In support of link comments

Dieter Schicketanz consultant
Reutlingen University

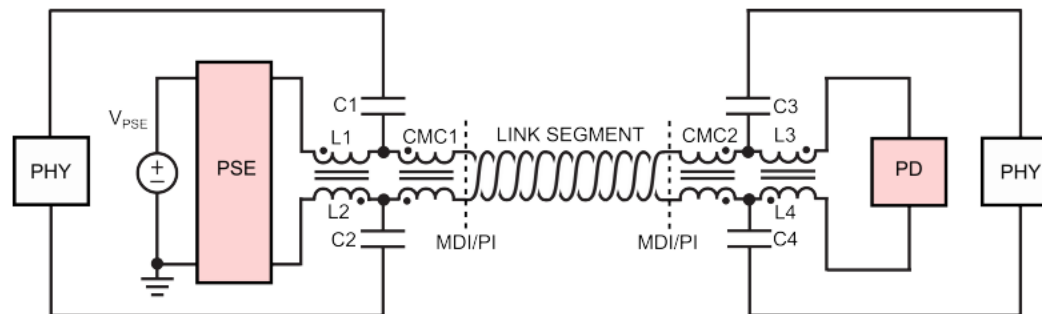
Where in clause 104 ?

From Dallas tutorial, excellent figure why not in bu?
